Omaha Public Power District
1623 Harney Omaha, Nebraska 68102
402/535-4000

May 31, 1984
LIC-84-121

Environmental Qualification of
Safety-Related Electrical Equipment

TER Meeting Response
Index and Introduction

FIGURE 1

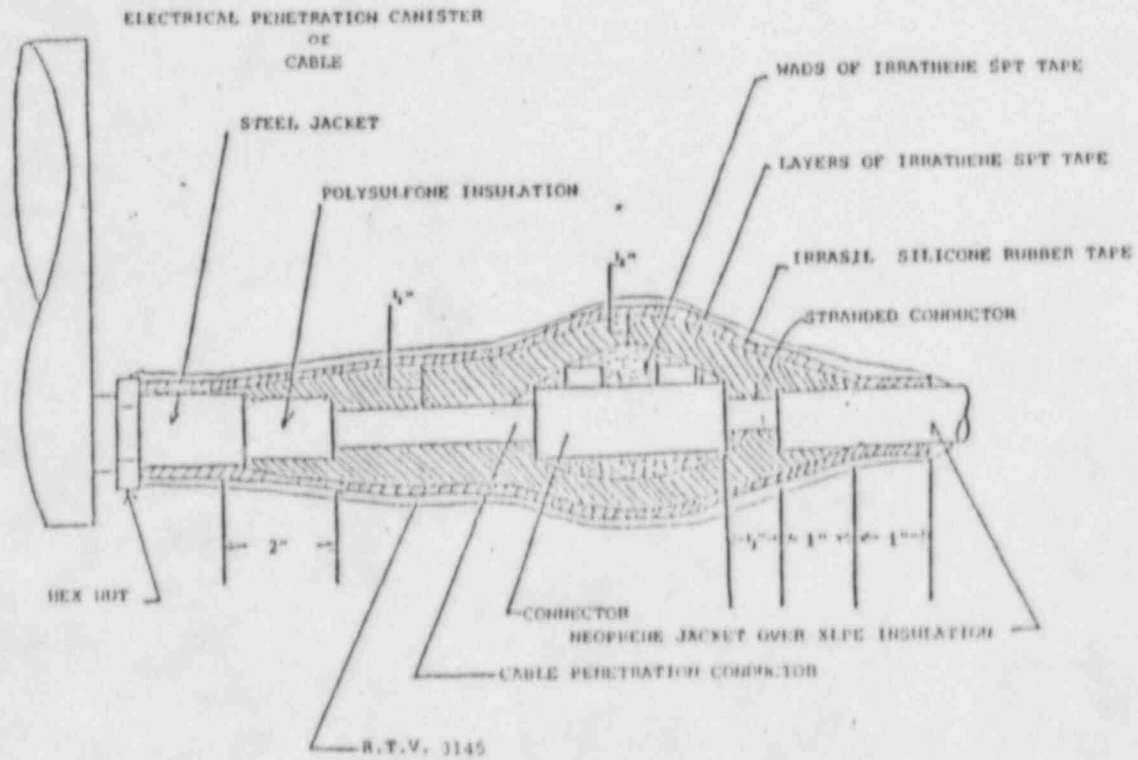
is a system in which the inner layers of tape ensure the electrical integrity of the circuit. The outer layer of RTV sealant (Dow Corning 3144 or 3145 clear) provides the protection and electrical insulation from normal and potential harsh environment parameters. A complete description of the motor lead cable splice system is detailed in Enclosure 9 to the District's letter dated August 26, 1981 (see Attachment 5). A description of the cable splice system at the electrical penetrations is provided as Figure 1, page 22 of the enclosed Wyle Laboratories Report, (see Attachment 6).

FIGURE 4
SER SECTION 3.3
MSLB TEMPERATURE CURVE

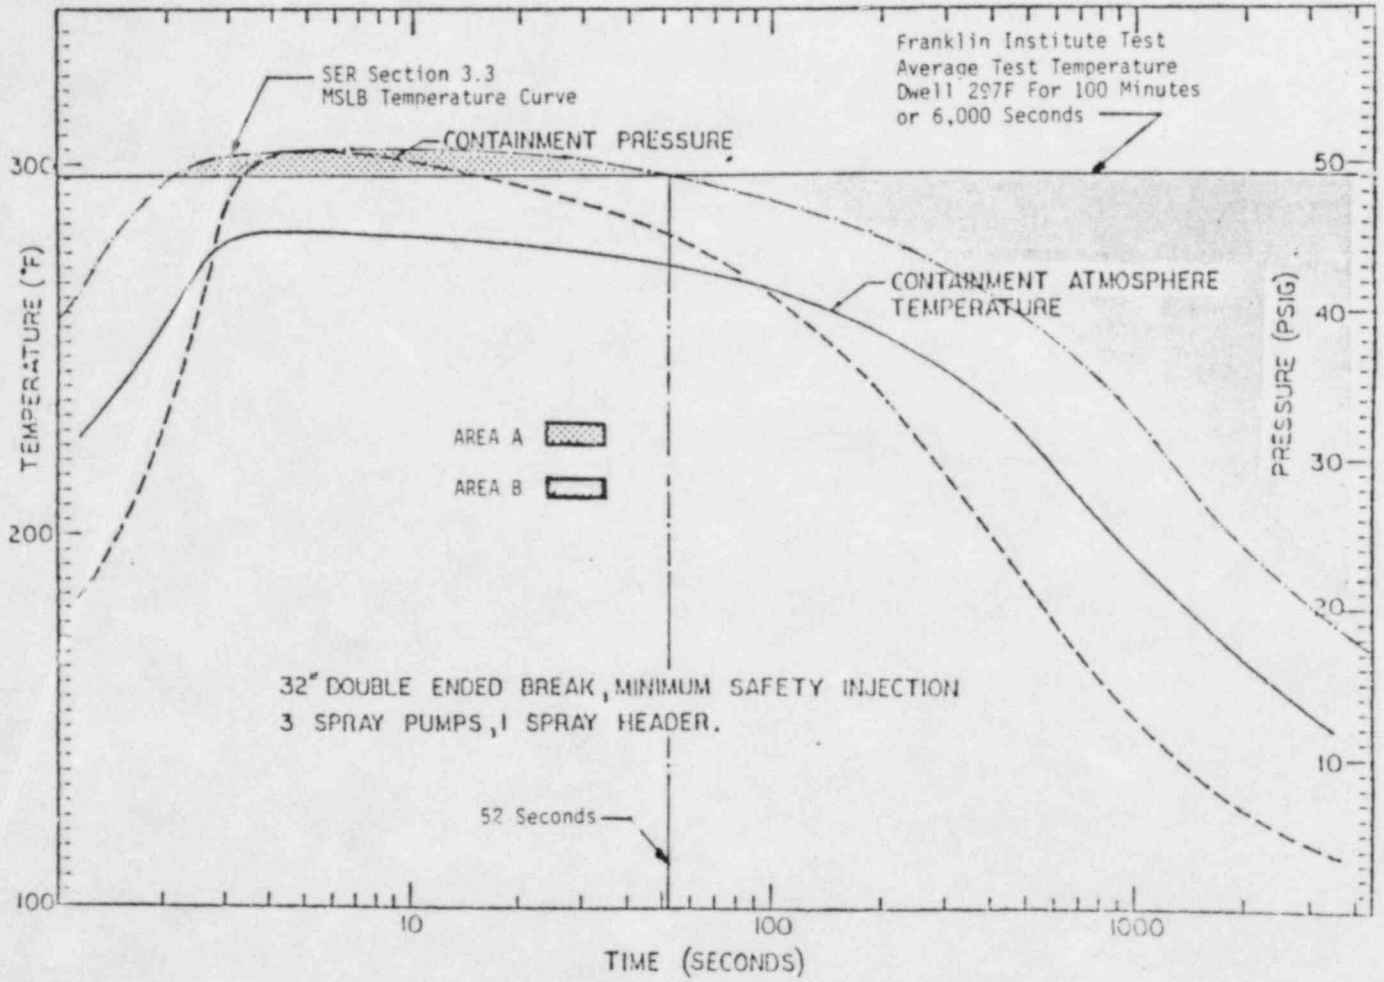
Figure 4 shows the SER Section 3.3 response 305F temperature profile. The shaded area is the MSLB 305F temperature profile, in excess of peak LOCA temperature. The estimated duration of this hypothetical condition will not be greater than 5 minutes.

Figure 4 includes the Franklin Test estimated average temperature of 297F. The 17F increase (305F-288F) over the calculated LOCA temperature curve is plotted as the SER Section 3.3 MSLB Temperature Curve. By inspection, it can be seen that the amount of heat added during testing was significantly greater than that required by the hypothetical SER Section 3.3, MSLB Temperature Curve (LOCA curve plus 17F). Note the logarithmic scale and that Area B is a major increase over Area A. Therefore, the Franklin Tests are judged to be conservative compared to the DBE temperature profile with its 305F imposed peak temperature.
